**ADDENDUM NO. 1**  
**October 28, 2020**  
**225902**

**RE: TOWN OF JERICHO, VERMONT**  
**JERICHO EWP 5038-007**  
**DRY LAID STONE MASONRY WALL RESCONSTRUCTION**

**FROM: DDK ENGINEERING-JV**  
28 North Main Street  
Randolph, Vermont 05060  
(802) 728-3376

CROSS SECTIONS

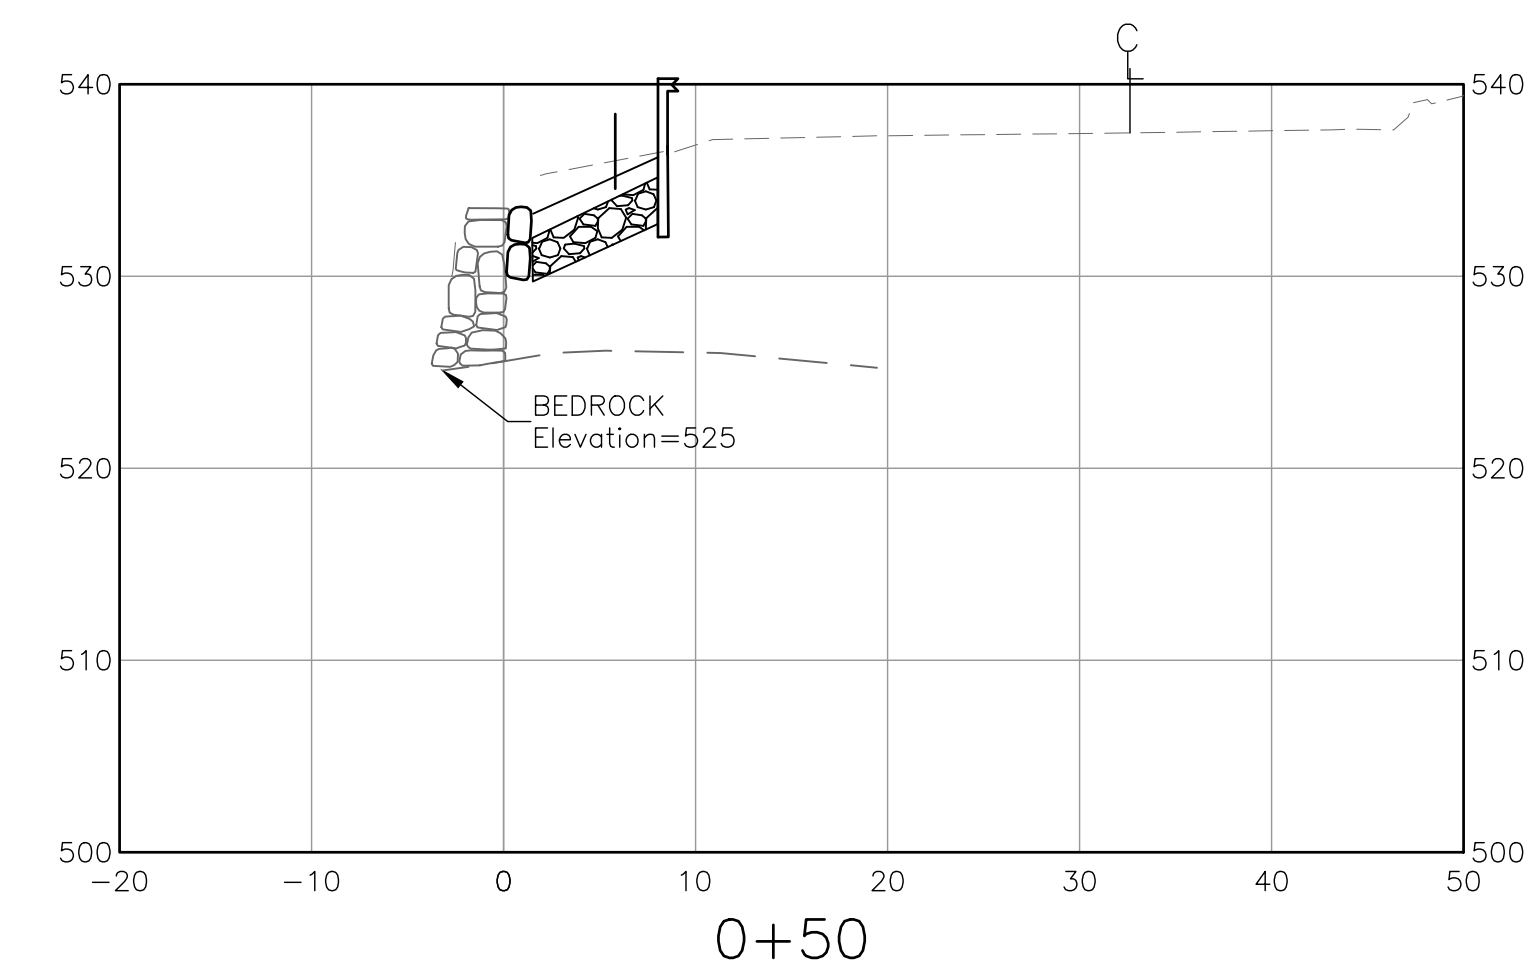
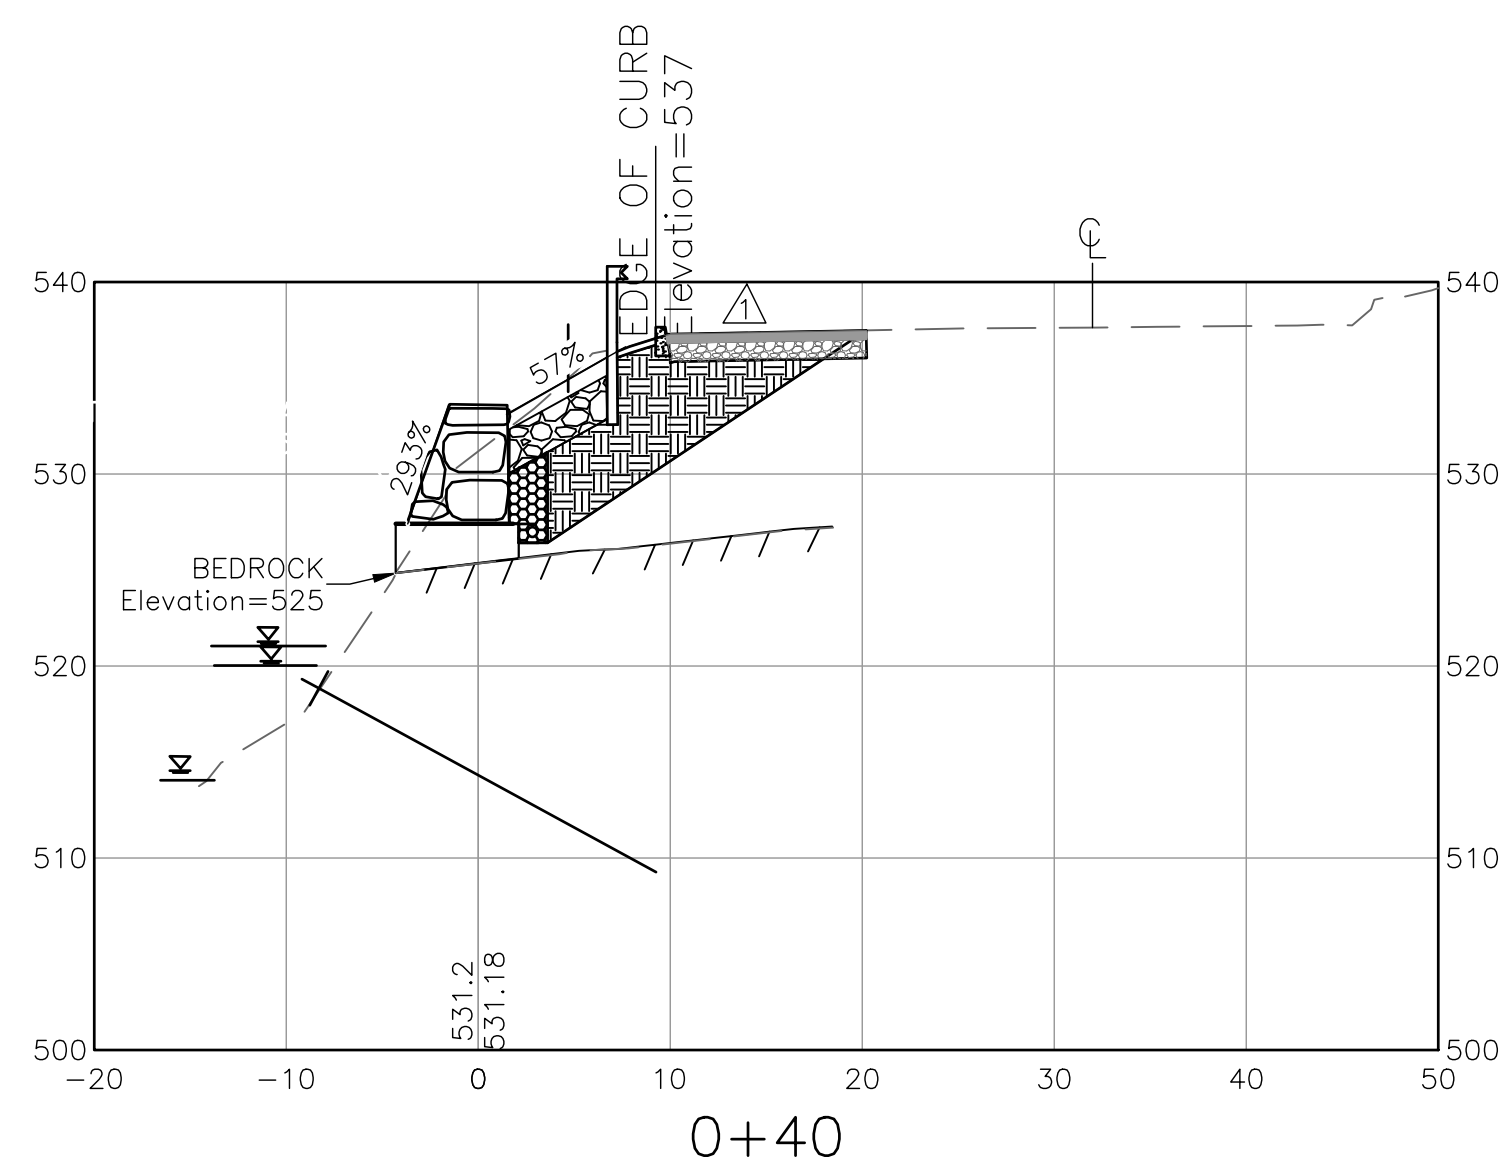
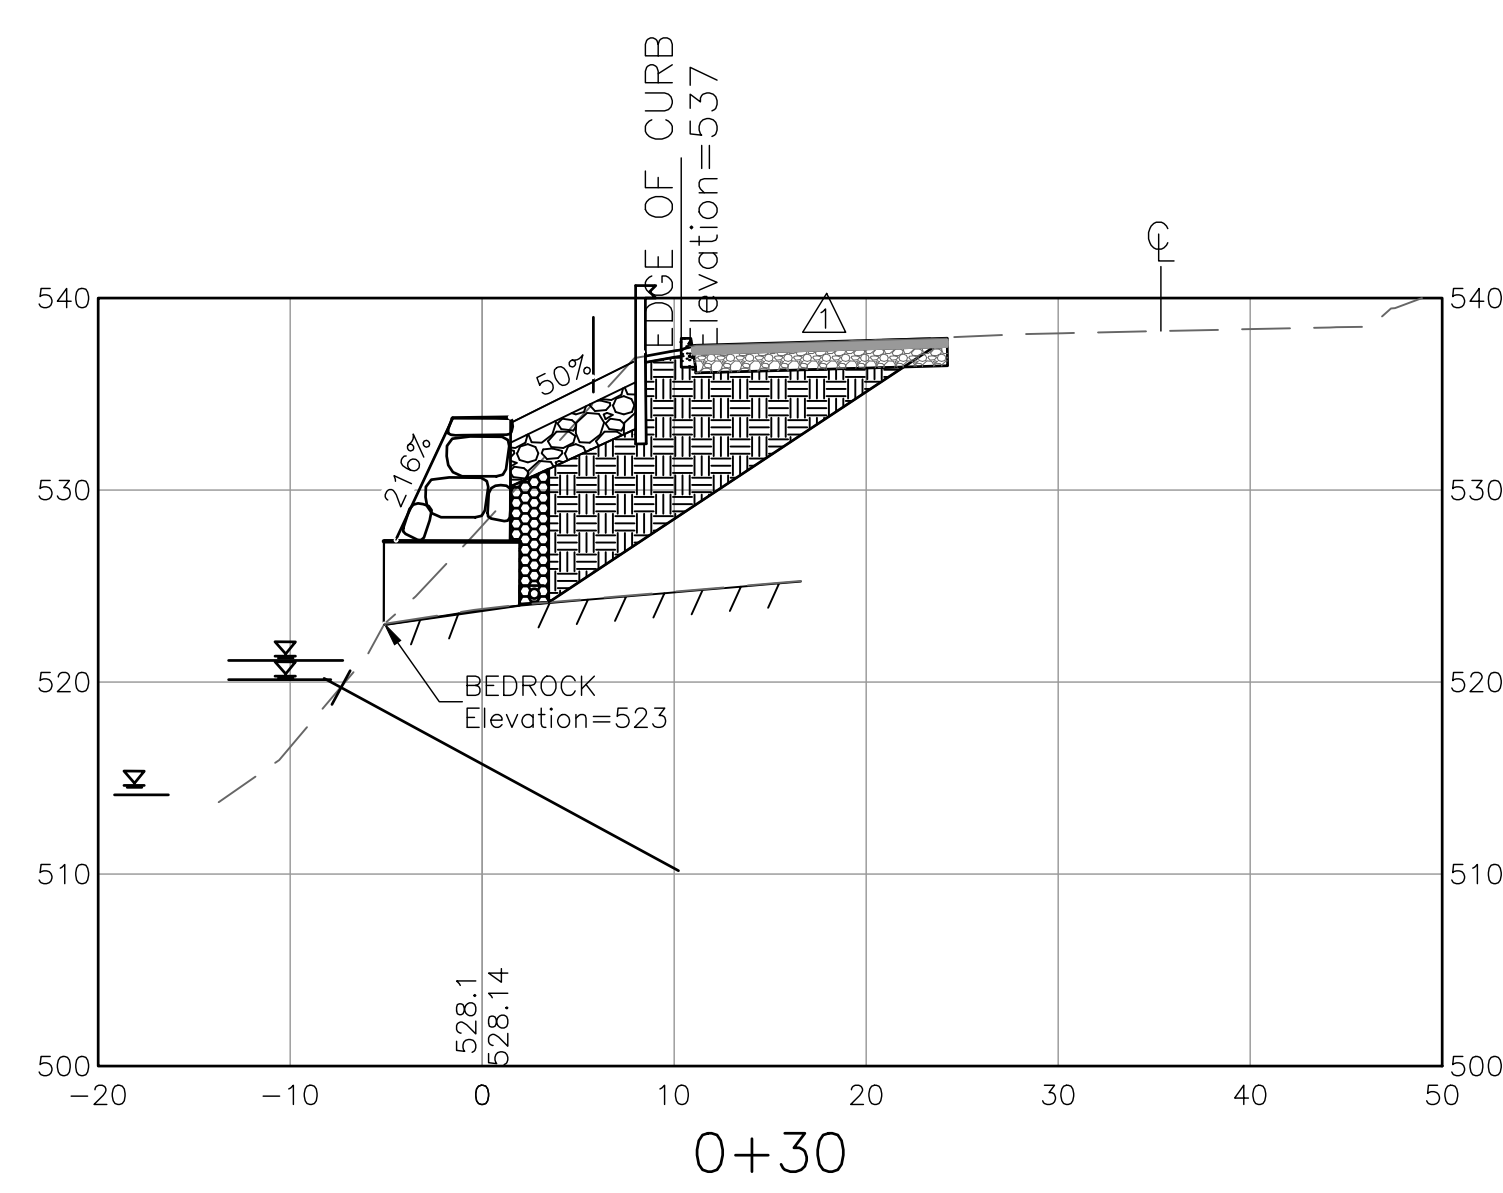
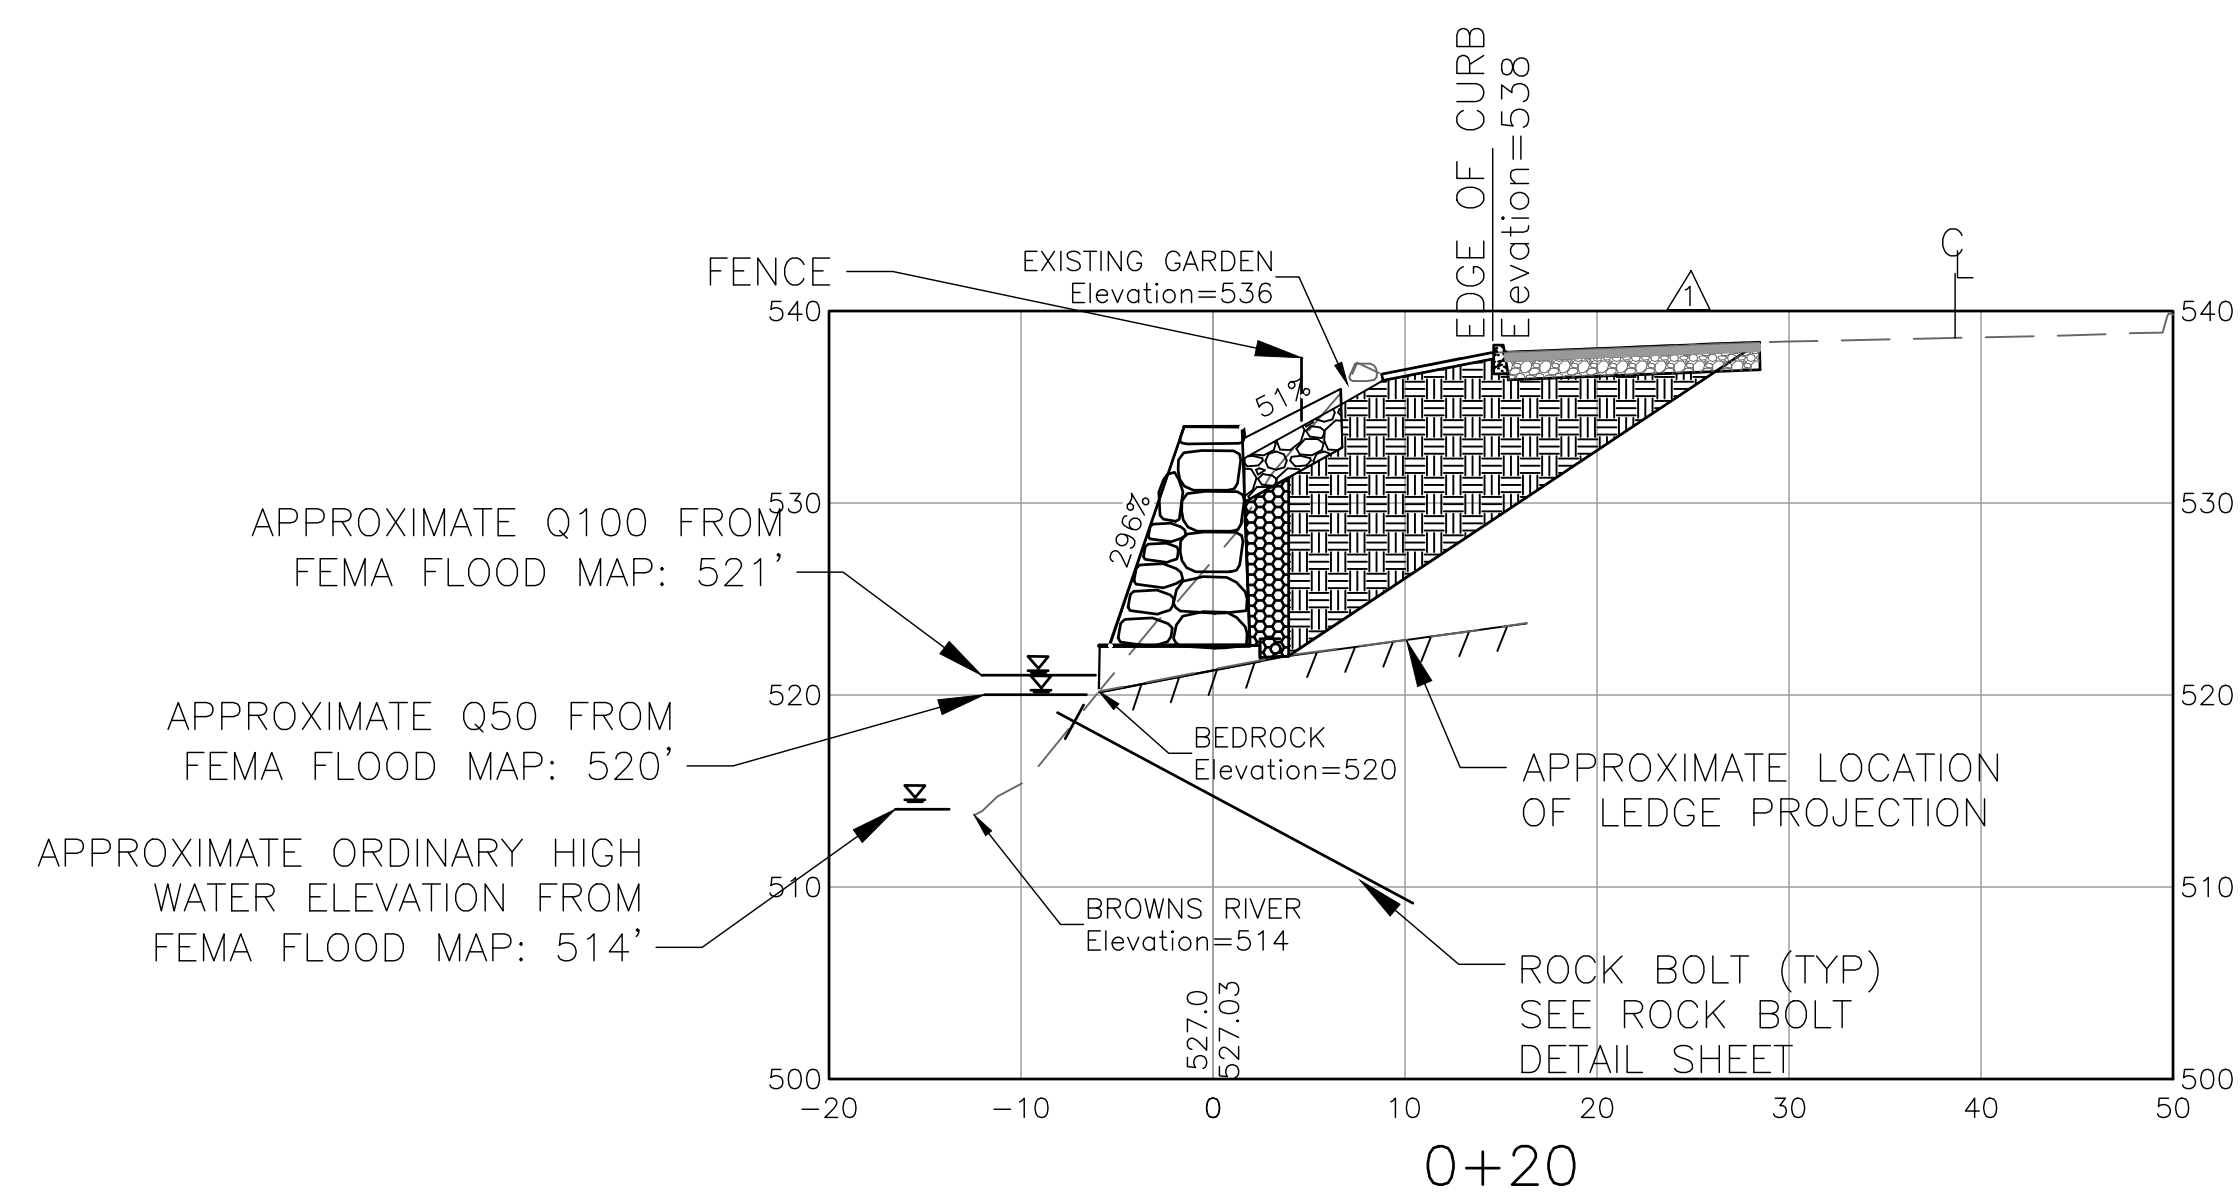
NO.	DATE	DESCRIPTION	BY	CK'D
1	10-27-2020	ROADWORK DETAILS, EXCAVATION LIMITS	KMF	GPH
